# Access Compliance Report

## Public Rights-of-Way

### (Curb Ramps)

Intersection ID: 10027126	Main Street: GARDEN_TR	Cross Street: N/A	Location: SE
ADA ID: 6789D7A23D45	Ramp Type: PerpDiag	Initial Pass/Fail: Fail	Overall Compliance: No
Severity Score: 13.75			
Codes/Mitigation Info/Possible Solution		Field Measurements/Component Compliance

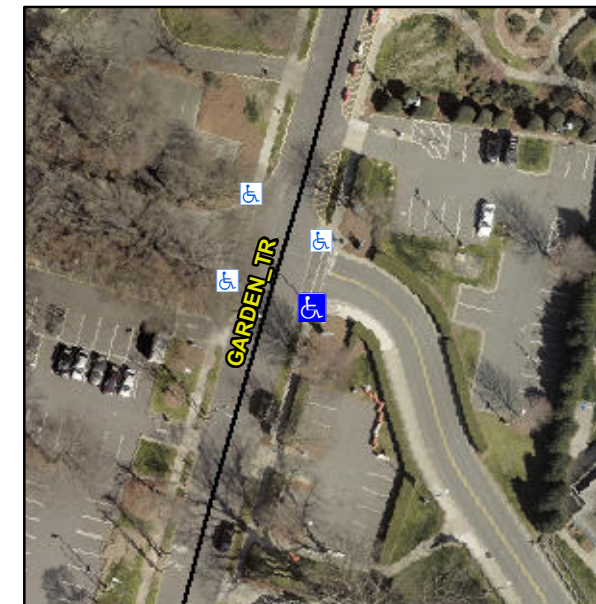
**Not Found, R304.2.2, R304.5.3**

Compliance	Description	Data	Compliance	Description	Data
N/A	Ramp Length (in)	69.0	No	Ramp Slope (%)	11.5
Yes	Ramp Width (in)	48.0	No	Ramp XSlope (%)	2.3
N/A	Flare Type LT	N/A	N/A	Flare Type RT	N/A
N/A	Flare Slope LT (%)	N/A	N/A	Flare Slope RT (%)	N/A
N/A	Flare Traversable LT?	N/A	N/A	Flare Traversable RT?	N/A
N/A	Landing Length (in)	N/A	N/A	DWS Provided?	N/A
N/A	Landing Width (in)	N/A	N/A	DWS Contrast?	N/A
N/A	Landing Slope (%)	N/A	N/A	DWS Length (in)	N/A
N/A	Landing X Slope (%)	N/A	N/A	DWS Full Width?	N/A
N/A	Landing Curb? (Y/N)	N/A	N/A	DWS Offset (in)	N/A
N/A	Shared Landing?	N/A			
N/A	Gutter Ponding?	N/A	N/A	Gutter Slope (%)	N/A
N/A	Gutter Lip Ht (in)	N/A	N/A	Gutter X Slope (%)	N/A
N/A	Painted X Walk1?	Yes	N/A	Painted X Walk2?	No
	X Walk 1 Direction	To NE		X Walk 2 Direction	To NW
N/A	X Walk 1 Width (in)	44.0	N/A	X Walk 2 Width (in)	N/A
	X Walk 1 Slope (%)	4.6		X Walk 2 Slope (%)	5.5
	X Walk 1 X Slope (%)	1.7		X Walk 2 X Slope (%)	1.7

**Remove & Replace Curb Ramp With Two New Directional Ramps or Equivalent.**
